# EXHIBIT A

Subject: Alstom's Proposed SCR System for St. Lawrence Cement

As I explained in our telephone conversation, CDM is an environmental consulting firm providing environmental assessments of St. Lawrence Cement's proposed cement plant in Greenport, NY. One of our assignments is to assess whether or not the air pollution control (APC) systems for the proposed cement plant meet present day APC laws and regulations. Since the project is located in the Northeast Ozone Transport Region, nitrogen oxide (NOx) and volatile organic compounds (VOCs) are subject to Lowest Achievable Emission Rate (LAER) control technology. Therefore, we are most interested in the feasibility of applying selective catalytic reduction (SCR) control to the proposed cement plant.

Subject: SCR System for St. Lawrence Cement

Figure 1  
Schematic of Greenport Preheater/Precalciner Section Showing Nominal Temperatures

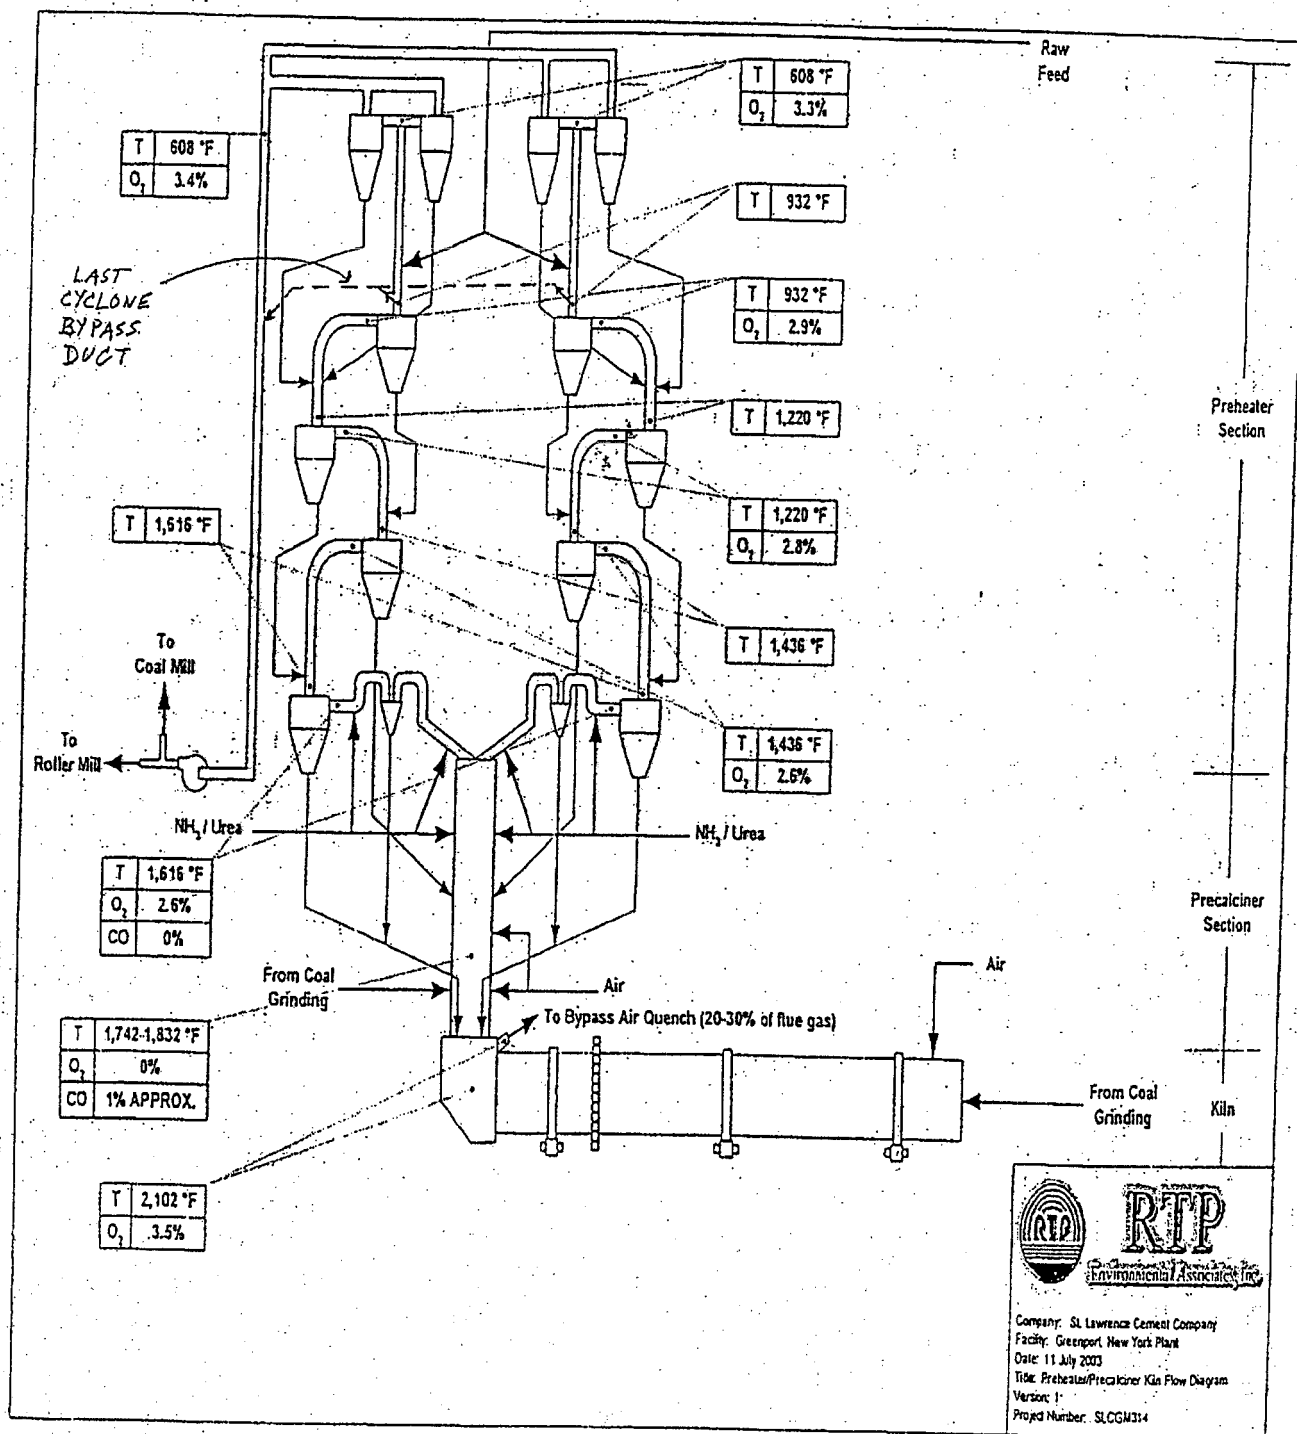
- 2 One of the problems with applying SCR to this project is the temperature of the preheater tower exhaust gas, minimum of 300°C (572° F), which is slightly lower than the desired minimum inlet temperature of 315°C (600° F) to 325°C (617° F). One of the possible solutions to this problem is to install a bypass duct around the last preheater cyclone. See attached Figure 1 showing kiln, preheater cyclones, proposed cyclone bypass duct and nominal design temperatures through the process. Assuming that the preheater tower exhaust temperature from the last preheater tower is at the minimum 572° F and its temperature needs to be raised to 617° F, only 5% of the 932° F gas stream going into the last cyclone would have to be bypassed to achieve the desired 617° F going into the SCR system. Note that similar types of economizer bypasses are commonly used on utility boiler SCR systems. Does this sound like a reasonable way to address the temperature problem? Do you see any technical flaws in it? Assuming such a cyclone bypass duct could be installed on the proposed cement plant, could Alstom agree to providing the performance guarantees stated above?

Figure 1  
Schematic of Greenport Preheater/Precaliner Section Showing Nominal Temperatures

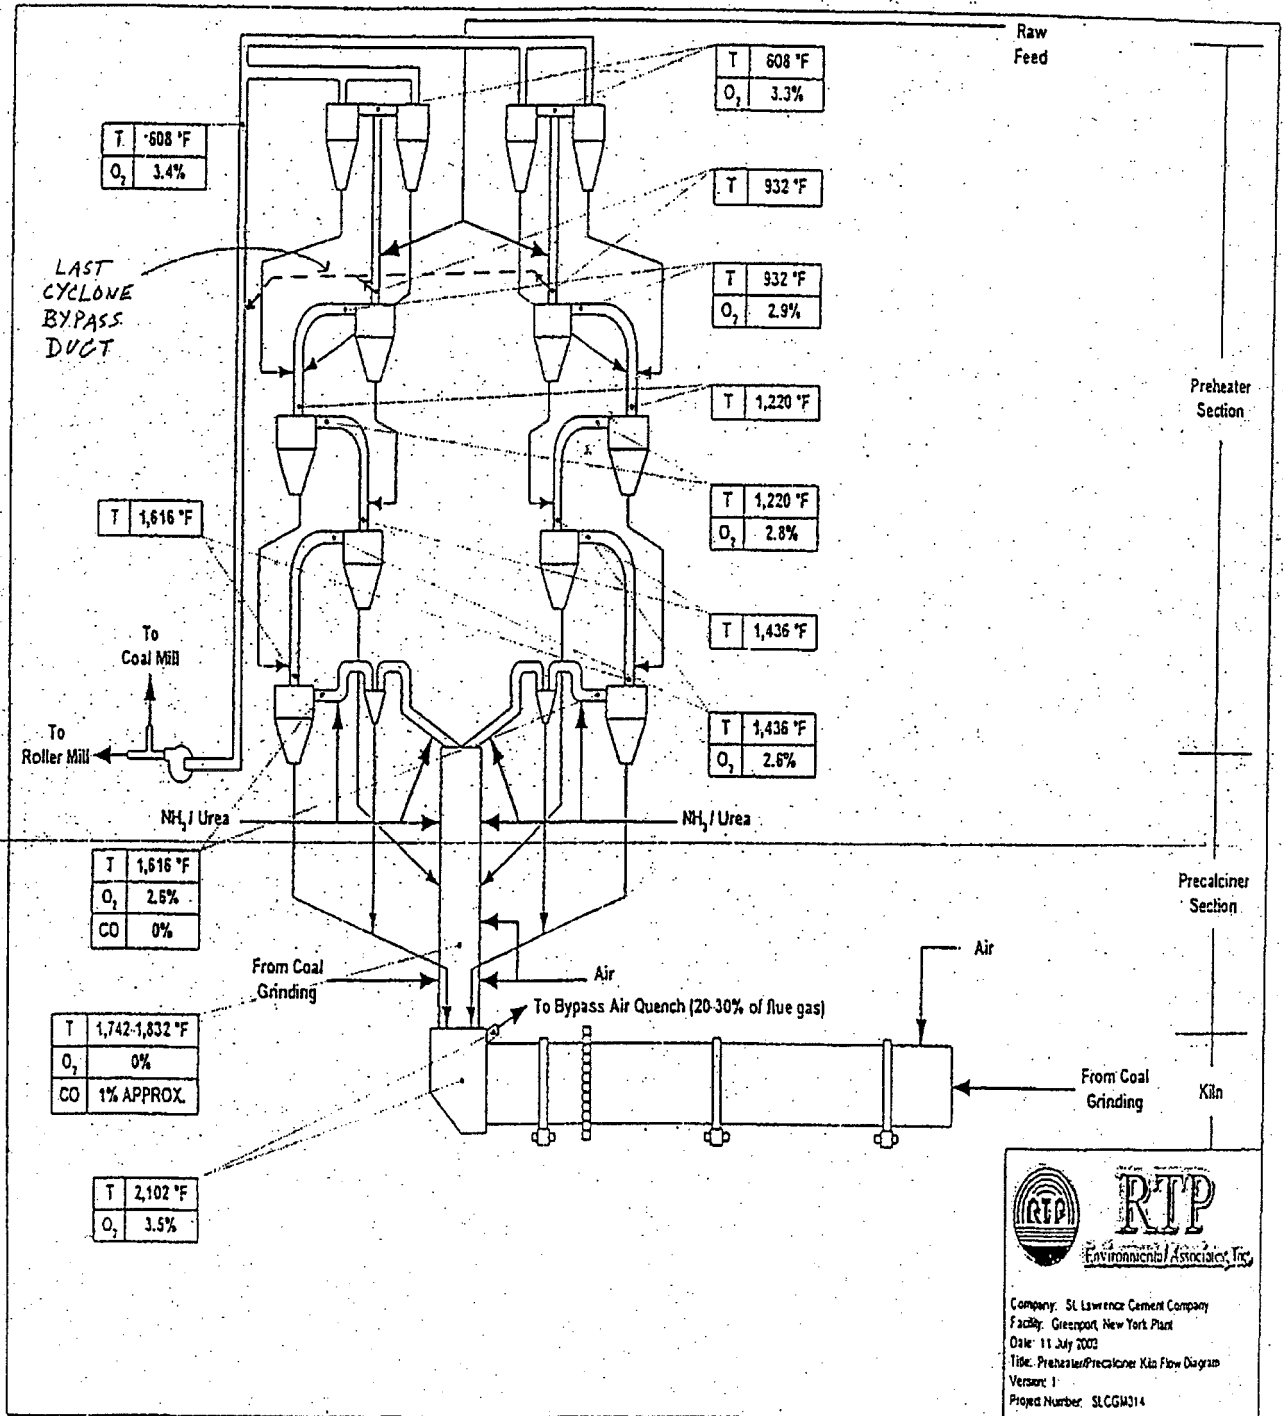
2. One of the problems with applying SCR to this project is the temperature of the preheater tower exhaust gas, minimum of 300°C (572° F), which is slightly lower than the desired minimum inlet temperature of 315°C (600° F) to 325°C (617° F). One of the possible solutions to this problem is to install a bypass duct around the last preheater cyclone. See attached Figure 1 showing kiln, preheater cyclones, proposed cyclone bypass duct and nominal design temperatures through the process. Assuming that the preheater tower exhaust temperature from the last preheater tower is at the minimum 572° F and its temperature needs to be raised to 617° F, only 5% of the 932° F gas stream going into the last cyclone would have to be bypassed to achieve the desired 617° F going into the SCR system. Note that similar types of economizer bypasses are commonly used on utility boiler SCR systems. Does this sound like a reasonable way to address the temperature problem? Do you see any technical flaws in it? Assuming such a cyclone bypass duct could be installed on the proposed cement plant, could KWH Catalysts agree to providing the performance guarantees stated above?

Figure 1  
Schematic of Greenport Preheater/Precalciner Section Showing Nominal Temperatures

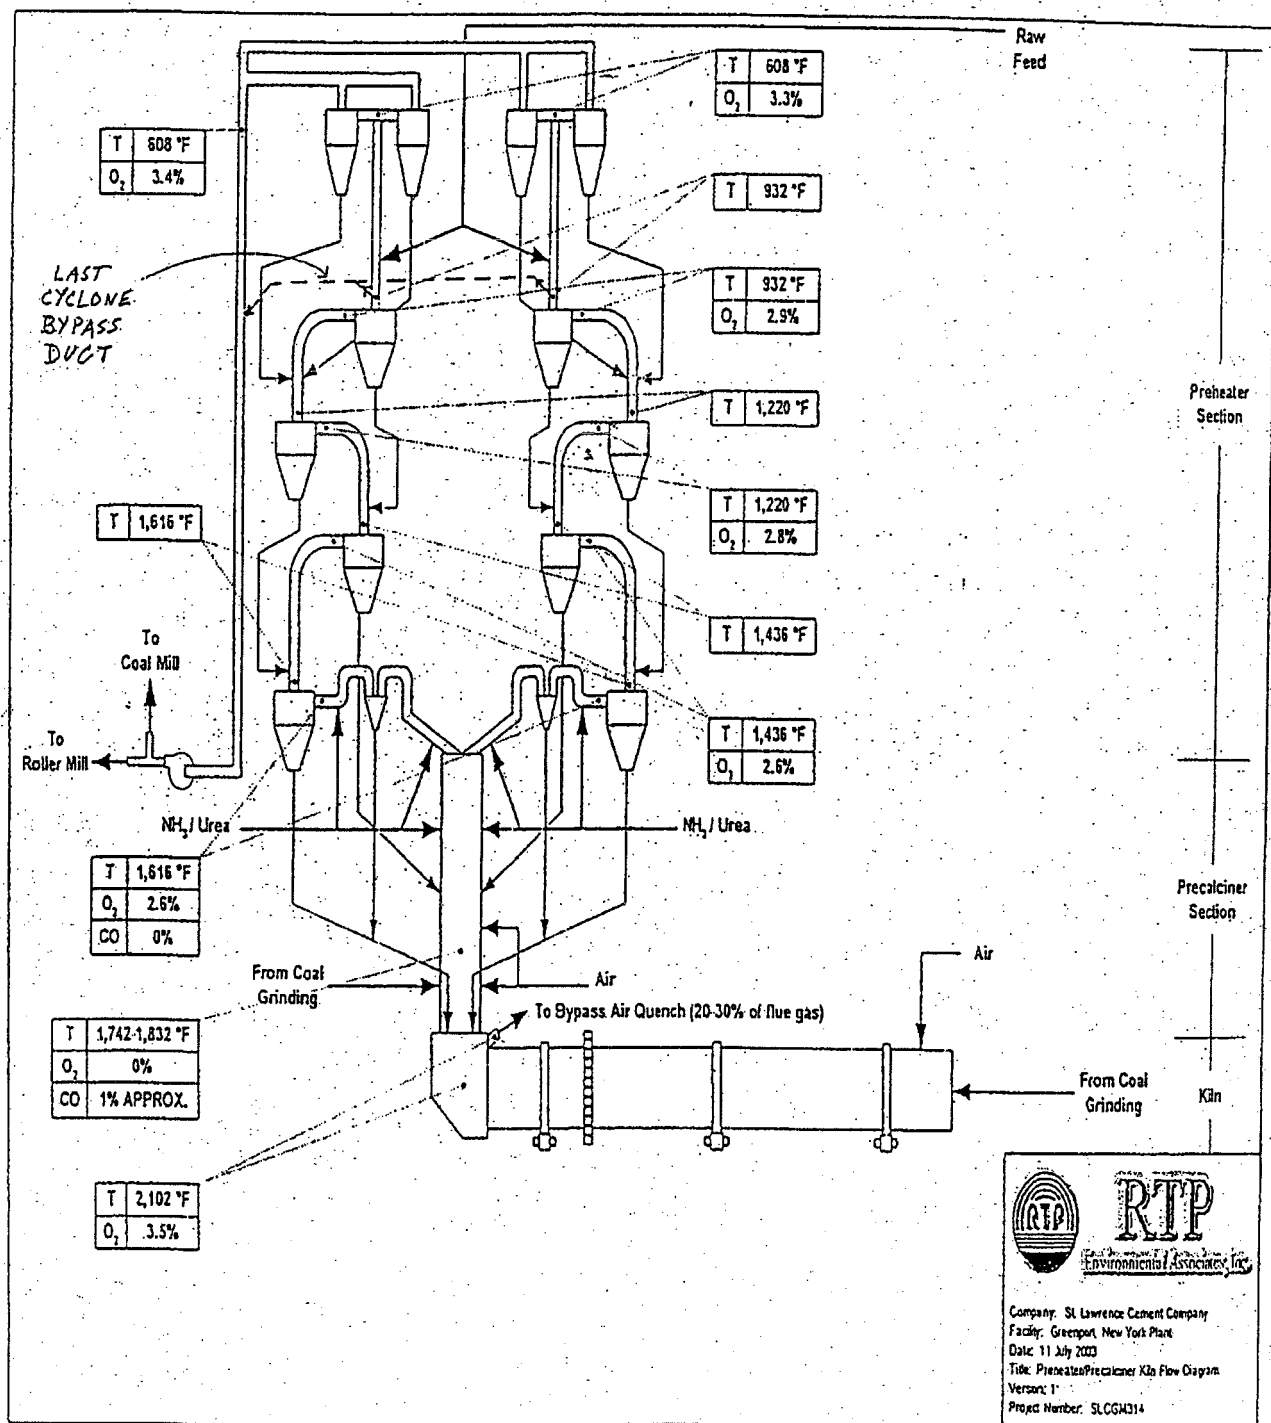
1. Can Hitachi America guarantee that their SCR system if installed on the proposed St. Lawrence Cement plant in Greenport, NY will meet the performance guarantees stated in Appendix 1? If there are any performance guarantees which you would have to take exception to, please indicate these. Process data on the proposed cement plant is included in Appendix 2, Cement Manufacturing Plant - Process Data.
2. One of the problems with applying SCR to this project is the temperature of the preheater tower exhaust gas, minimum of 300°C (572° F), which is slightly lower than the desired minimum inlet temperature of 315°C (600° F) to 325°C (617° F). One of the possible solutions to this problem is to install a bypass duct around the last preheater cyclone. See attached Figure 1 showing kiln, preheater cyclones, proposed cyclone

Figure 1  
Schematic of Greenport Preheater/Precalciner Section Showing Nominal Temperatures

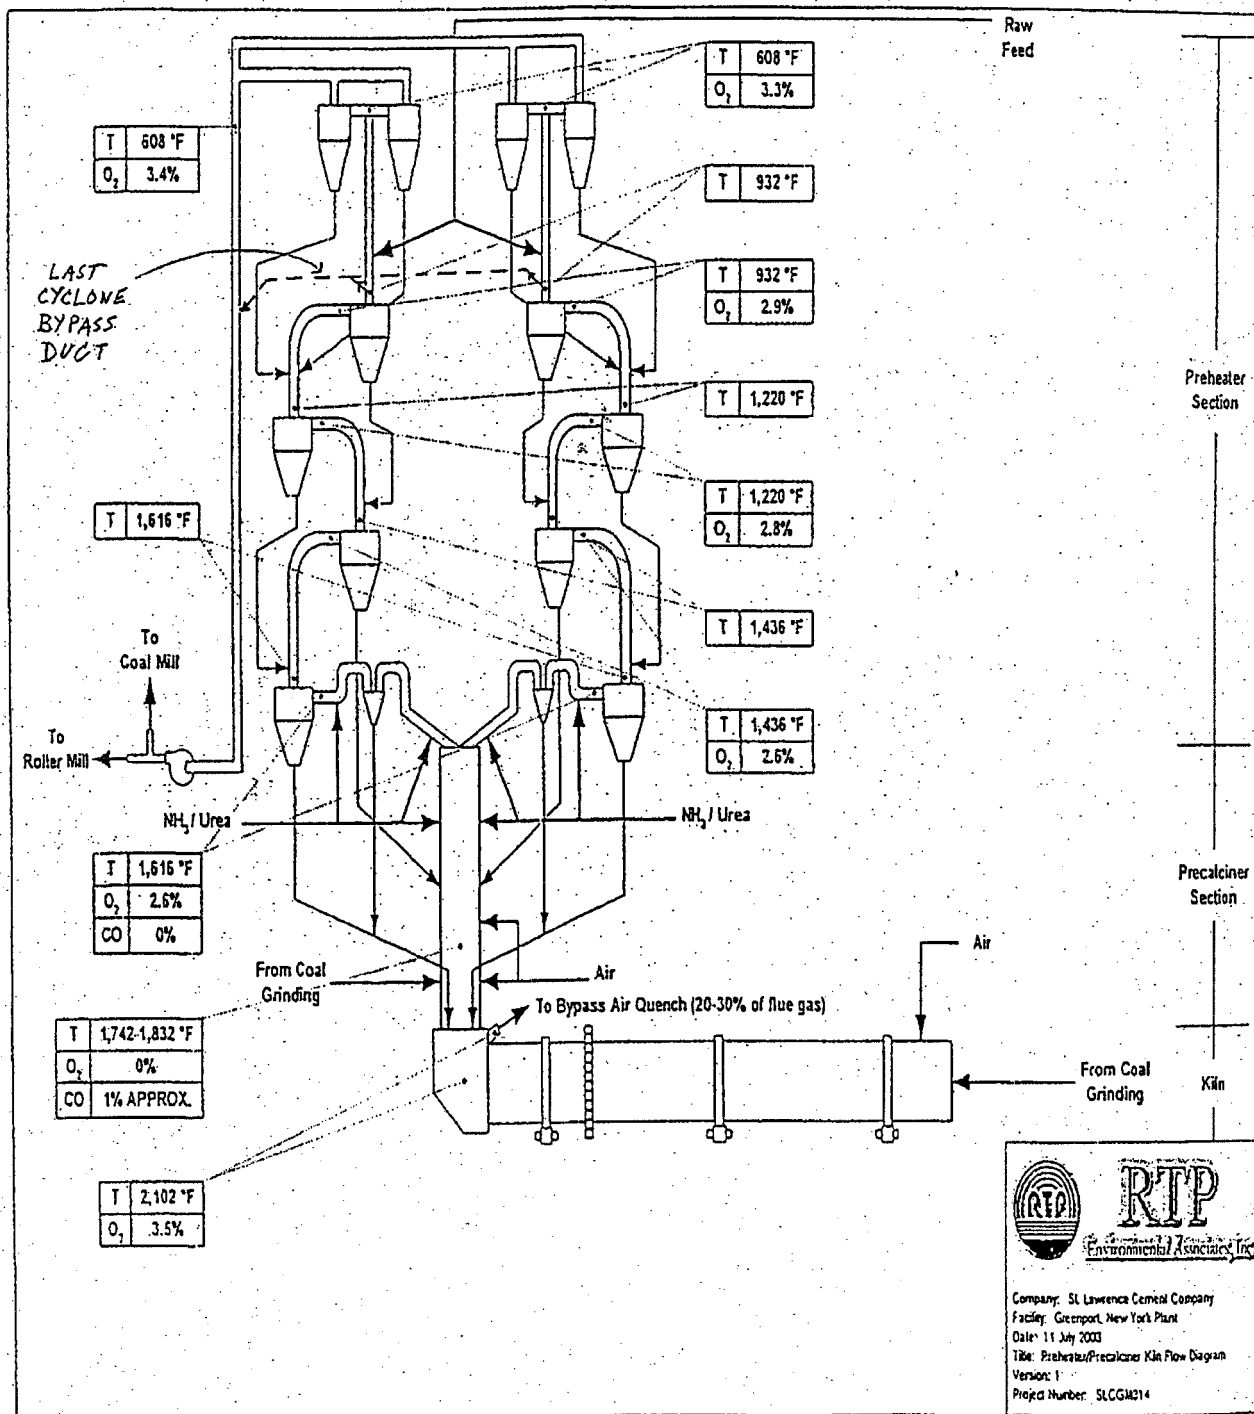
2. One of the problems with applying SCR to this project is the temperature of the preheater tower exhaust gas, minimum of 300°C (572° F), which is slightly lower than the desired minimum inlet temperature of 315°C (600° F) to 325°C (617° F). One of the possible solutions to this problem is to install a bypass duct around the last preheater cyclone. See attached Figure 1 showing kiln, preheater cyclones, proposed cyclone bypass duct and nominal design temperatures through the process. Assuming that the preheater tower exhaust temperature from the last preheater tower is at the minimum 572° F and its temperature needs to be raised to 617° F, only 5% of the 932° F gas stream going into the last cyclone would have to be bypassed to achieve the desired 617° F going into the SCR system. Note that similar types of economizer bypasses are commonly used on utility boiler SCR systems. Does this sound like a reasonable way to address the temperature problem? Do you see any technical flaws in it? Assuming such a cyclone bypass duct could be installed on the proposed cement plant, could Haldor Topsoe agree to providing the performance guarantees stated above?
